## Planning Commission Staff Report

**Meeting Date:** May 24, 2021

**Description:** **Wildhorse Village, (Lot 1) SDSP:** A Site Development Section Plan, Landscape Plan, and Lighting Plan for the 8.6 acre tract of land located east of the future Burkhardt Place extension, south of Wild Horse Creek Road, and west of Chesterfield Parkway West.

SHEET NO.:  
SDSP-1.0

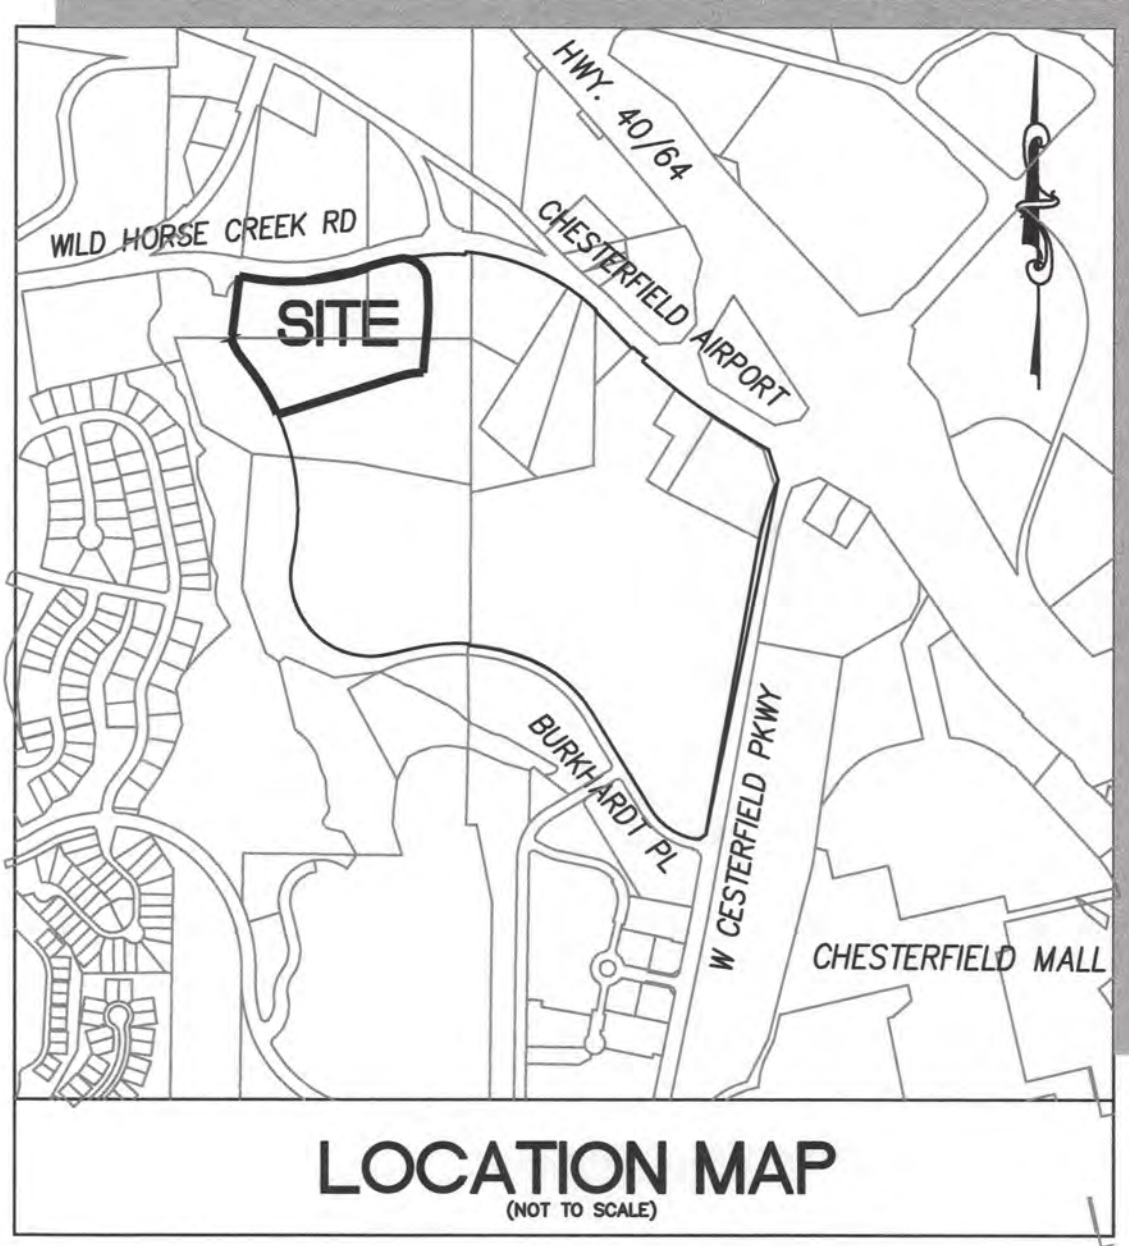
The 8.6 acre Lot 1 configuration is identical to the approved ASDCP. Located on Lot 1 are 72 attached single family lots proposed ranging from 1,487 – 2,120 square feet in size. There is common ground independent to Lot 1 which includes landscaping and the internal roadway system. Before a building permit may be approved to construct a house on an individual lot, both an approved Record Plat for the entire Wildhorse Village development and an approved Record Plat individual to Lot 1 creating the 72 lots and Common Ground is required.

The internal roadway system is a private roadway system that has two access points into the Lot 1 development. One access location is on Burkhardt Place (future public road) and one access location is on Wildhorse Lake Blvd (future private road). The access locations are in the same location as the approved ASDCP and meet all of the City's access management standards. The internal roadway system for Lot 1 is 26' wide with a 4' sidewalk throughout the site. The primary parking will be secured by individual garages. There will be an additional 47 off street parking spaces located along the internal roadway.

**SECTIONS**  
SCALE: HORZ: 1"=40'  
VERT: 1"=40'

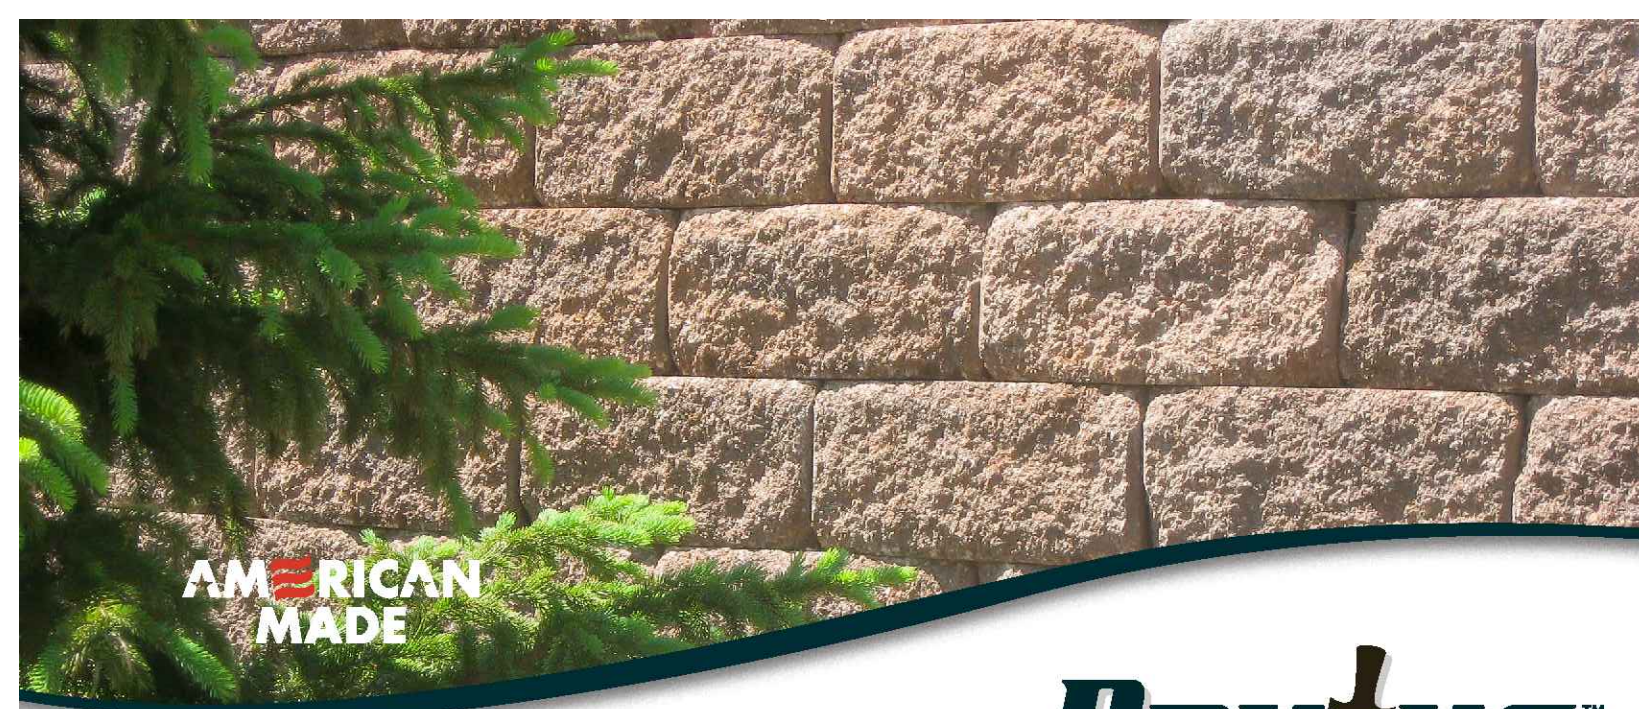
Due to the topography, there are 2 retaining walls proposed within the site. The first retaining wall is in the southwestern portion of the site. The wall varies in height and at the tallest section is 11.5'. The elevation of Wildhorse Lake Blvd near this wall is at 508' and the elevation of the nearby internal roadway is 520'. The second retaining wall is located along the northern edge of the site. The internal roadway near the wall is around 522' in elevation and directly north at Wild Horse Creek Road is 512' in elevation. The wall is a long segment which varies in height. The wall at its tallest is 7' in height. The image on the following page (Figure 3) depicts the approximate location of the retaining walls and the location of the elevations referenced above.

FENCE DETAIL

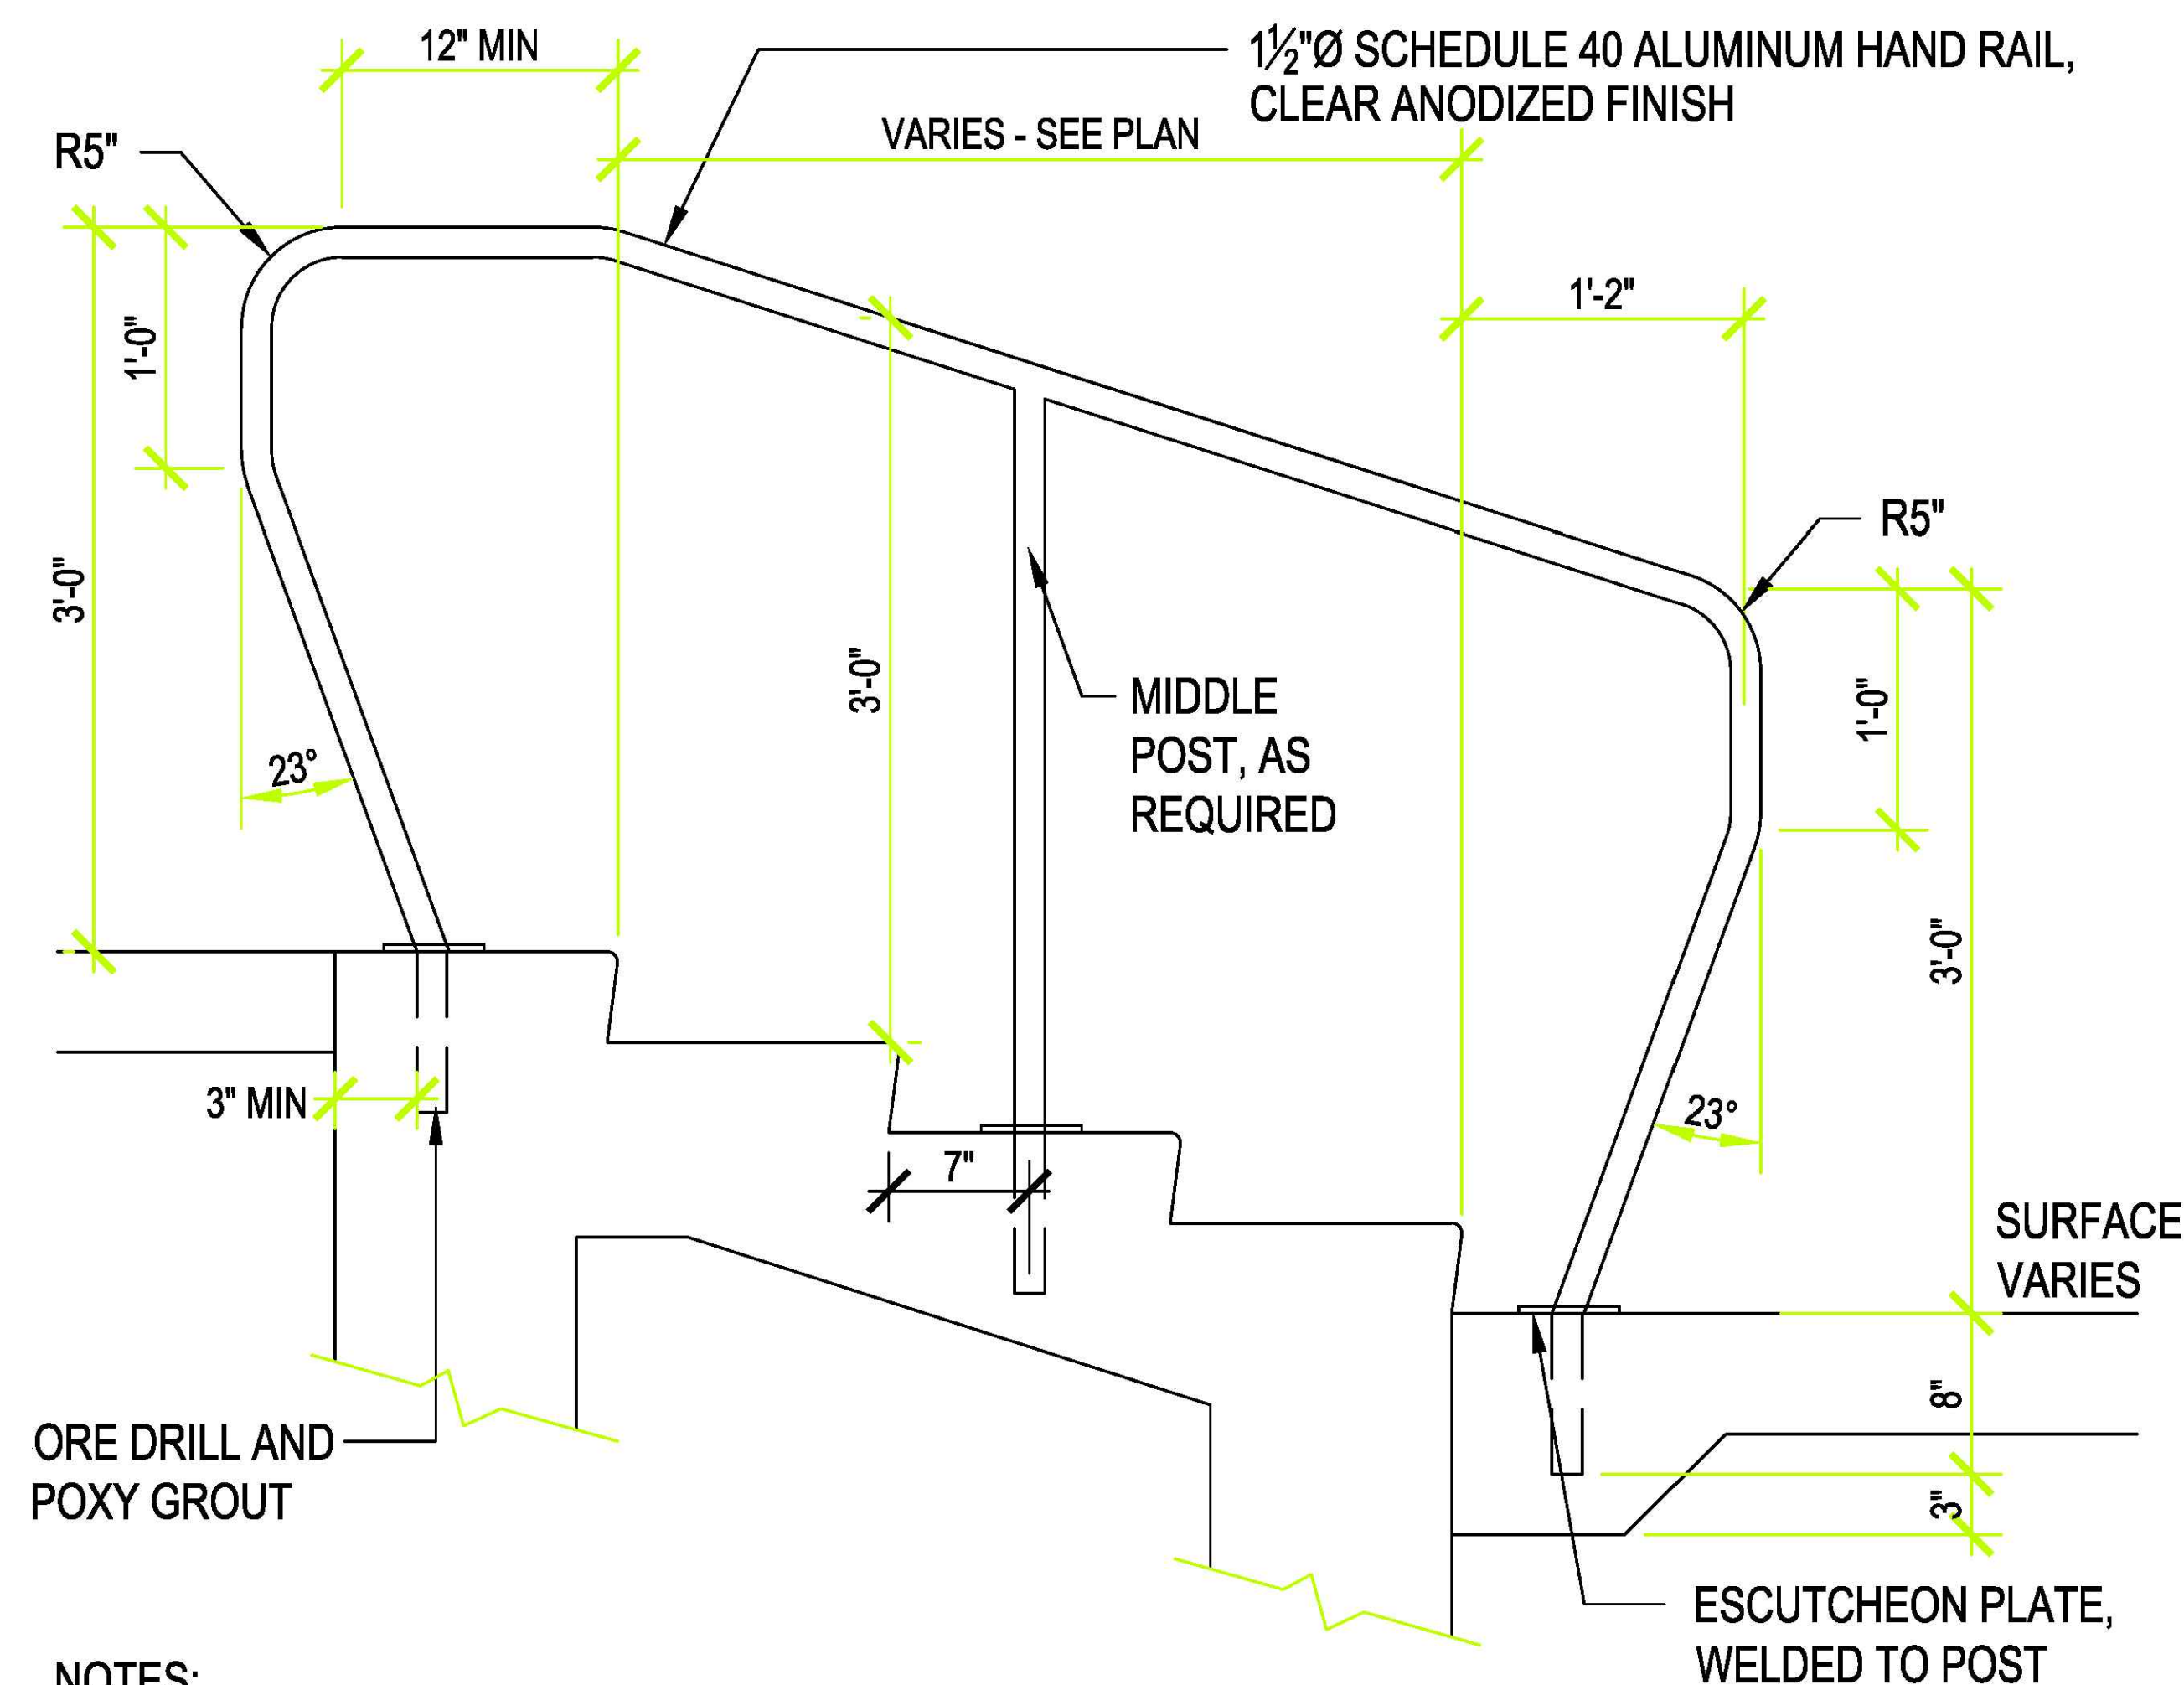
An ornamental fence is required by building code to be placed along the top of the retaining walls due to their size. The applicant has provided a detail of the black aluminum fence, along with an image of the retaining walls chosen for the development and are provided within the Planning Commission packet. This is the same fence and retaining wall as Lot 6, which was approved by the Planning Commission on May 10<sup>th</sup>, 2021.

DRAWING NO.  
**E1.100**

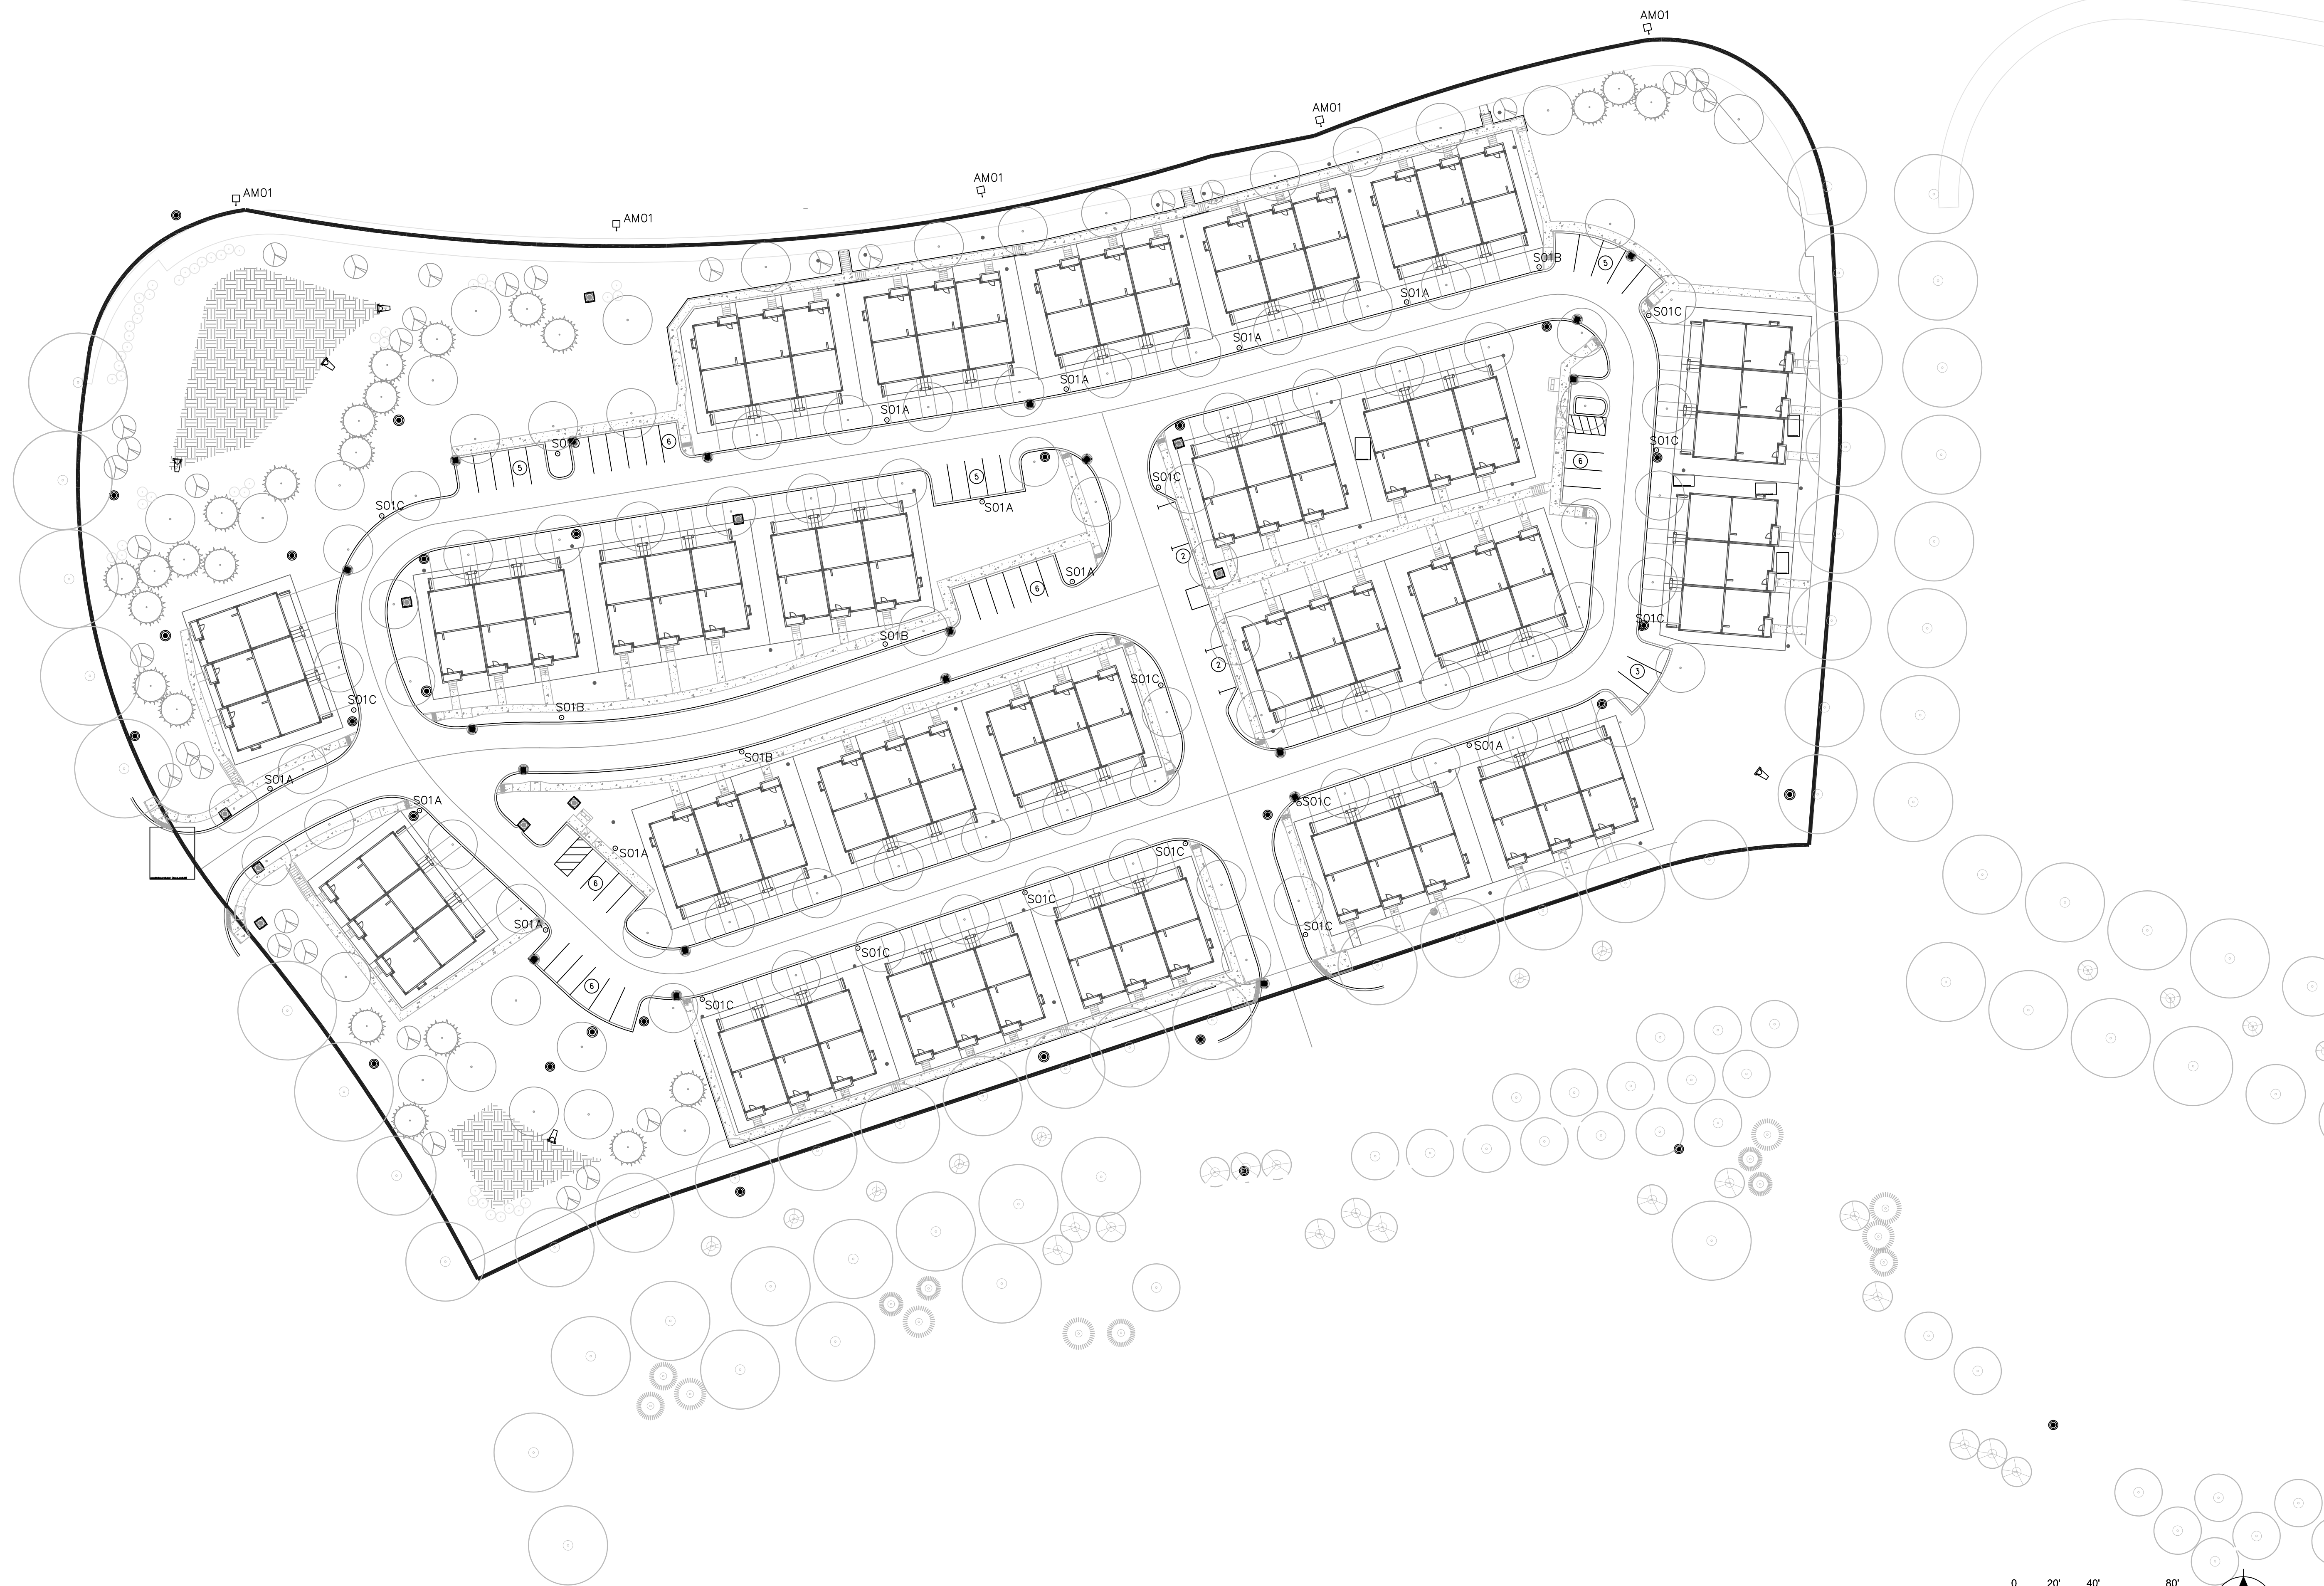
The internal roadway has a series of street lights. The fixture proposed matches the fixture approved within the Lighting Fixture Concept Plan for the development. The height of street lights is 16’8” and the maximum light level is 2.2 foot candles which conforms to the lighting standards of the City’s Unified Development Code.
